## DESIGN & ACCESS STATEMENT

### RE-DEVELOPMENT PROPOSAL FOR 5 HERMIT PLACE LONDON NW6 4BZ

Alan Power Architects Ltd 13 Needham Road London W11 2RP 020 7229 9375 December 2014

Fig. 28 - Diagram comparing the existing garage and the proposed roof profile

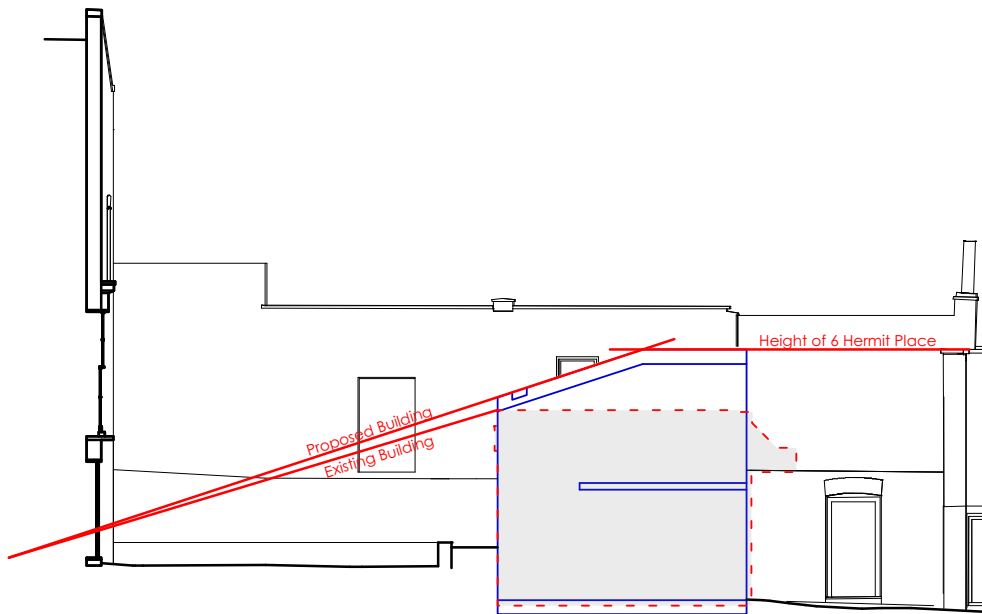
*"However in respect of the overall height and bulk of the development, I would not support an increase in height of the proposed building and would expect it to be built to the same height of the existing dwelling, to ensure it retains its relationship within the streetscene as a small scale backland development."*

*"Whilst there are mews properties adjacent to the site these form a row of mews', the application site is a stand alone building which I assume at some time would have been the rear garden of No.1 Priory Road and appears as an outbuilding/garage associated to that property. The character of the building as a small scale building should be retained."*

This is an opportunity site to create a striking contemporary building that enhances the character of the street. By increasing the height of part of the building it can begin to have a stronger relationship to the rest of the mews while still maintaining its individual position, and without having an adverse effect on No.1 Priory Road.

We have no information on this provenance of the existing structure, as with the rest of the mews it may have originally been stables. The height of the proposal has only been increased over the existing height on half of the footprint and has been reduced to lower than the existing height on the other half (see fig. 29). By increasing part of the height of the building to mirror the height of No.6 Hermit Place, a visual link will be created between the proposal and the other mews buildings, giving the street a relationship and completing the vista up Hermit Place.

Fig. 32 - Proposed Front Elevation

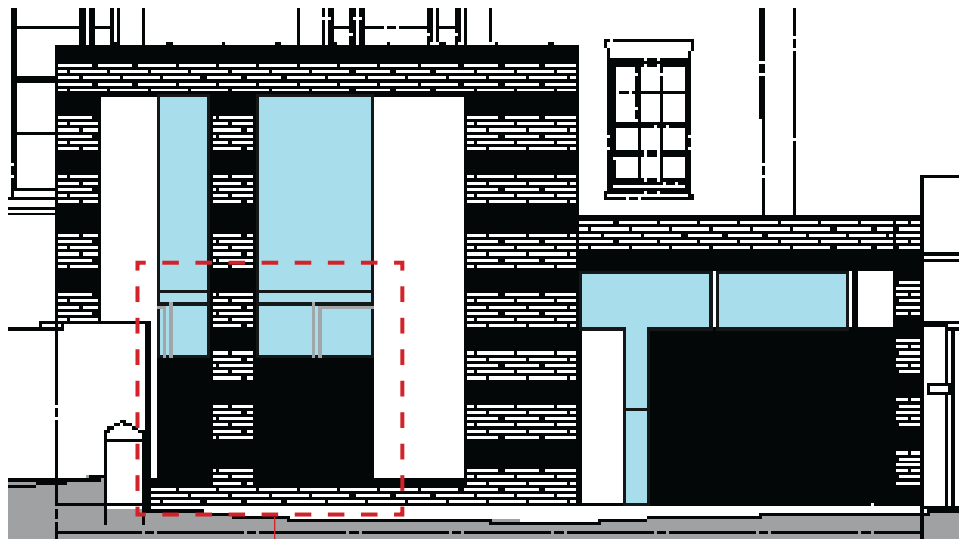
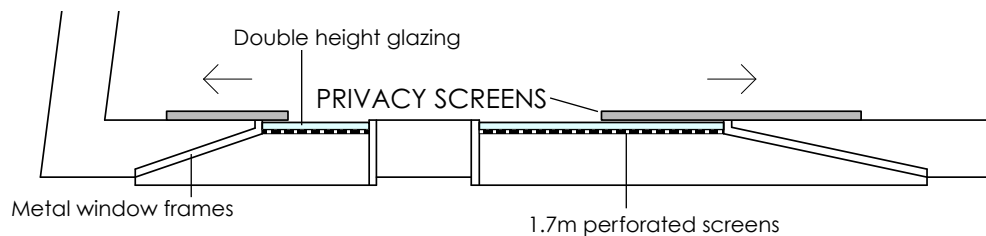
*“With regard to the outlook, the proposed dwelling would be single aspect with outlook via the south west facing elevation. The openings at ground floor level would be large to ensure a good level of outlook, however I am concerned there would be almost no privacy for the future occupiers, the large windows to the living area face directly onto a public area therefore afforded future occupiers little privacy, which I don't consider to be an acceptable standard of accommodation and should be revised, potentially in light of the design comments above.”*

The privacy afforded to the future occupants has been accommodated at ground floor level by 1.7m high perforated decorative screens attached to the external facade as well as full height movable internal screens, composed of timber framed translucent glass. The adjustable screens can be slid in front of the large windows to give flexibility for greater levels of privacy to the living area in certain situations, whilst still allowing light in through the section of glazing above the screen (see fig. 32 & 33).

Fig. 35 - Diagram comparing the existing garage and the proposed roof profile

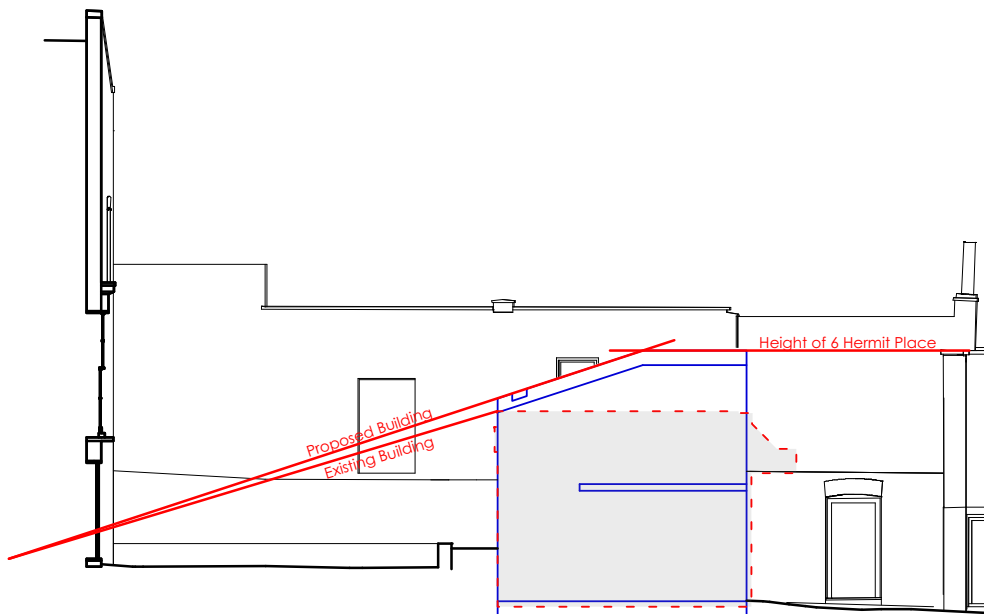
*“With regard to No.1 Priory Road, the additional height above ground floor level is not considered appropriate due to proximity to this neighbouring resident and the reduction in their outlook.”*

The shape of the roof has been designed such that the impact on No.1 Priory Road would be minimal. A section through the site shows the comparison between the proposed roof and the existing building (see fig. 35). The materials and design will provide a much improved visual outlook over the construction of the existing garage.
